TO: Howey-in-the-Hills DRC
CC: J. Brock, Town Clerk, S. O’Keefe, Town Administrator
FROM: Thomas Harowski, AICP, Planning Consultant
SUBJECT: Simpson Parcel Concept Plan
DATE: September 2, 2021

The following comments are based on the concept plan prepared by the Green Consulting Group dated August 25, 2021. This meeting is being considered a pre-application meeting for the proposed single-family subdivision. The project covers about 93 acres located at the southeast corner of the intersection of Revels Road with SR-19. The plan proposed 260 lots with 60-foot lot widths (215 lots) and 70-foot-wide lots (45 parcels).

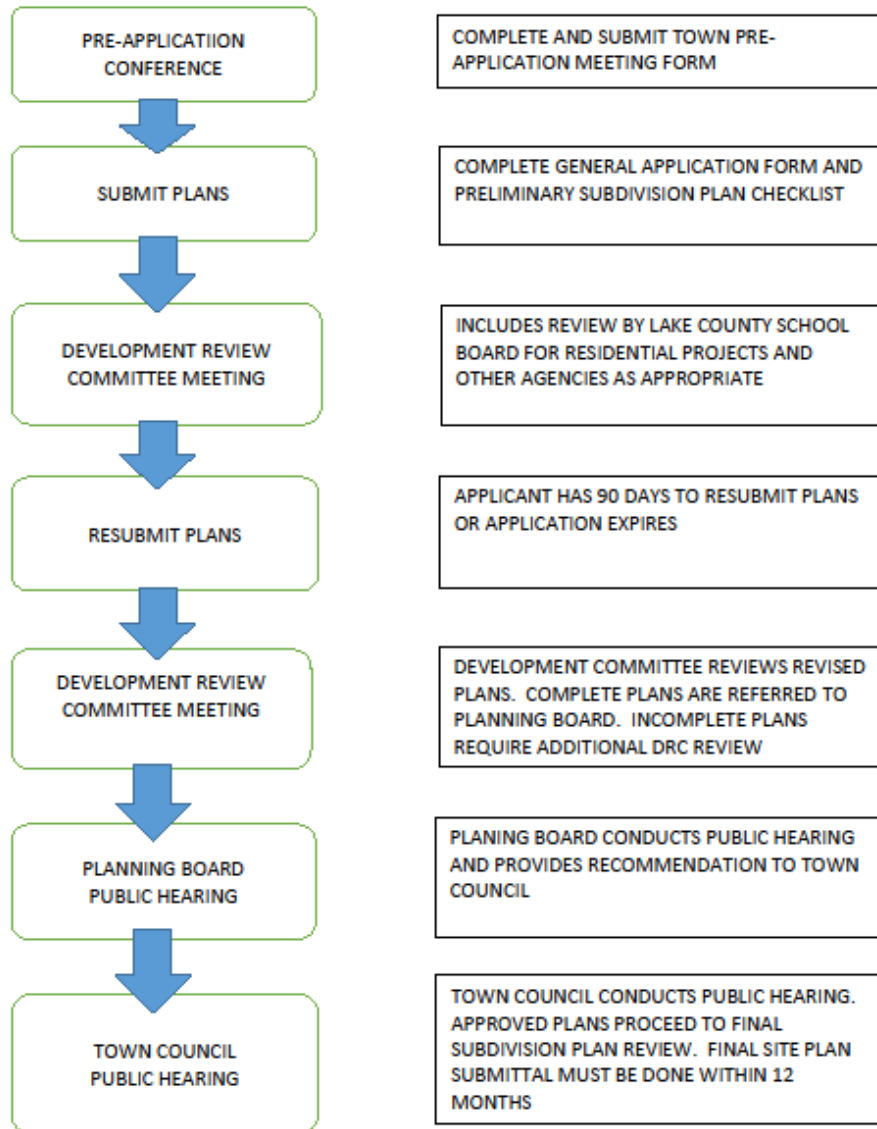
The two areas designated as open space on the concept plan are essentially useless in this application and should be incorporated into residential lot area.
